TYNDALL
ENGINEERING & DESIGN, P.A.

Reference: Engineering Services
Focht Residence
99 Curtis Dr.
Erwin, NC 28339
TE&D Project No.: DRB2201-0154_C

May 30, 2023

November 16, 2023

LSTA12 Strapping Installed

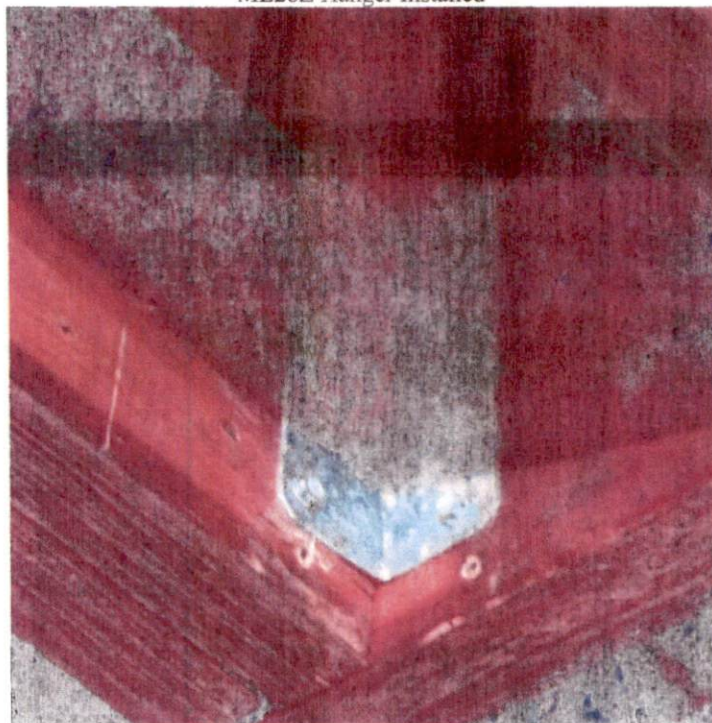
1. The pantry (2) 2 x 4 stud column was secured to the LVL header with a Simpson LSTA12 strap per the structural plan.
2. The improperly installed Simpson ML28Z hanger was removed and reinstalled per the manufacturer specifications.

1. The LSTA12 strap was installed to the plan specified (2) 2 x 4 stud column and the existing (2) 1-3/4" x 9-1/4" LVL header. No further modification is required.
2. The ML28Z was removed and re-installed tightly per the manufacturer's specifications to the beam. No further modifications are required.

(2) 2 x 4 stud column with
Simpson LSTA12 strap

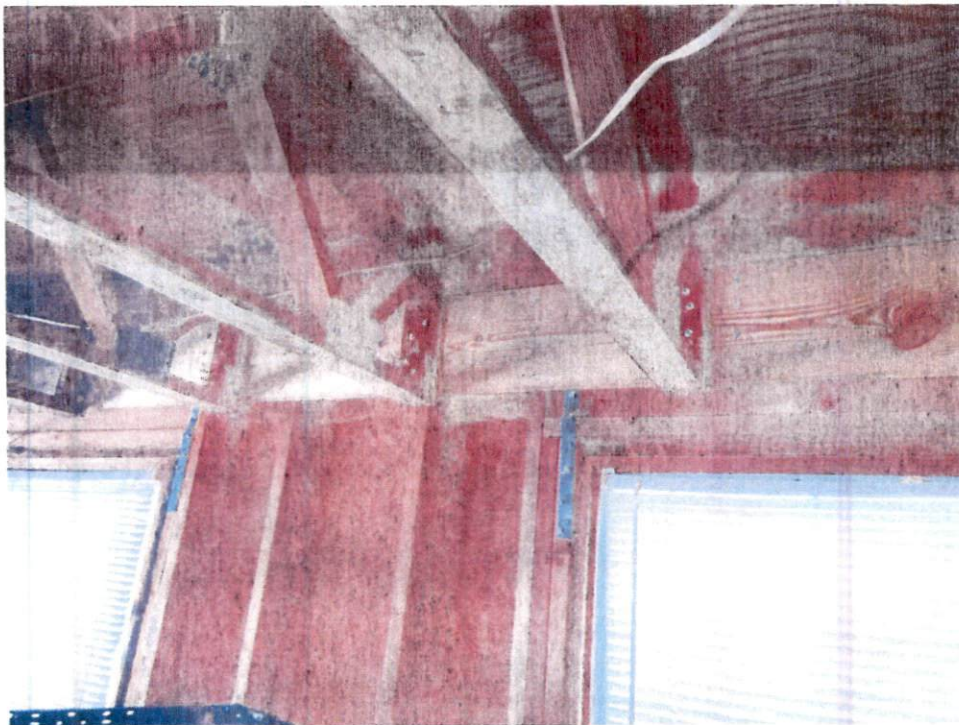
3. The pantry stud column was secured to the LVL header with a Simpson LSTA12 strap per the structural plan.
4. The interior corner of the LVL beams was secured together with a Simpson ML26Z connector per our previous letter sealed on 11/18/2022.

1. The (2) 2 x 10 beam was secured to the LVL valleys with (4) SDWS Screws at each end. No further modification is required.
2. The 2 x 6 header was installed with (1) 2 x 4 jack and (1) 2 x 4 king stud at each end in lieu of the plan specified (2) 2 x 4 jacks at each end. Based on our observations and analysis, this configuration is adequate to support the anticipated loading conditions. No further modification is required.
3. We observed the LSTA12 strap to have been installed to the door framing and 2 x 4 header, not to the plan specified (2) 2 x 4 stud column and the existing (2) 1-3/4" x 9-1/4" LVL header. The Simpson LSTA12 strapping is to be installed as specified in the plan.

Item 3) Secure (2) 2 x 10 Header to Valley Rafters.

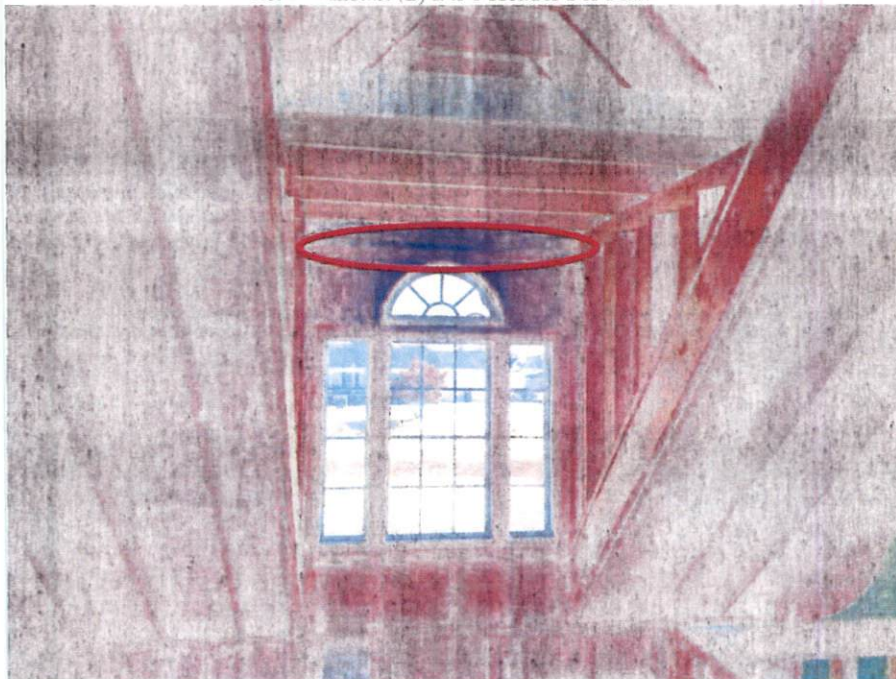
3. We observed the (2) 2 x 10 beam at the right gable was not secured to the valleys with Simpson LUS28-2 connectors per the structural plan. Based on our observations and analysis, the existing configuration is inadequate to support the anticipated loading conditions. TE&D recommends securing the existing (2) 2 x 10 beam to the LVL valley rafters with Simpson LUS28-2 connectors OR (4) SDWS screws at each end.

Item 4) Install (2) 2 x 6 Header Per Plan

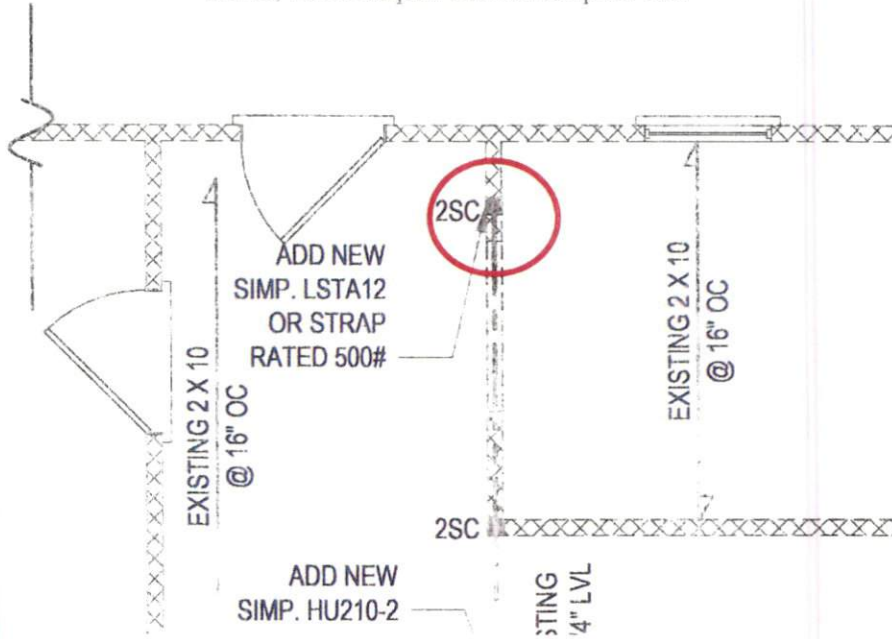
4. We observed the (2) 2 x 6 header was not installed over the window in the left gable. Based on our observations and analysis, the existing configuration is inadequate to support the anticipated loading conditions. TE&D recommends installing the (2) 2 x 6 header per the original structural plan.

Item 5) Install Simpson LSTA12 Strap Per Plan

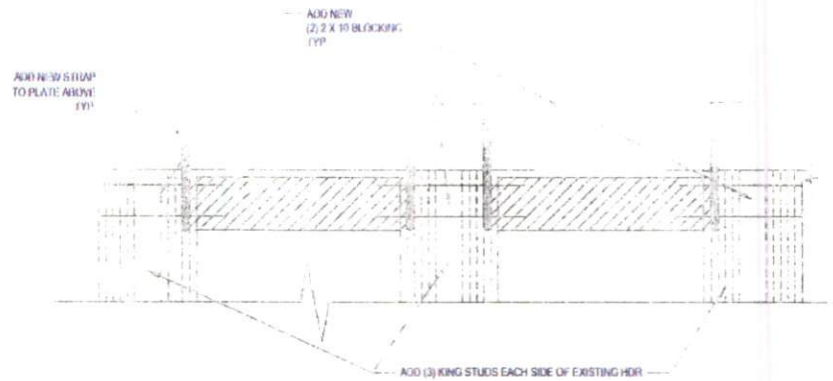
5. We observed the stud column at the rear of the pantry door was not secured to the header with Simpson LSTA12 strap installed per the structural plan. Based on our observations and analysis, the existing configuration is inadequate to support the anticipated loading conditions. TE&D recommends securing the stud column to the header with a Simpson LSTA12 strap per the structural plan.
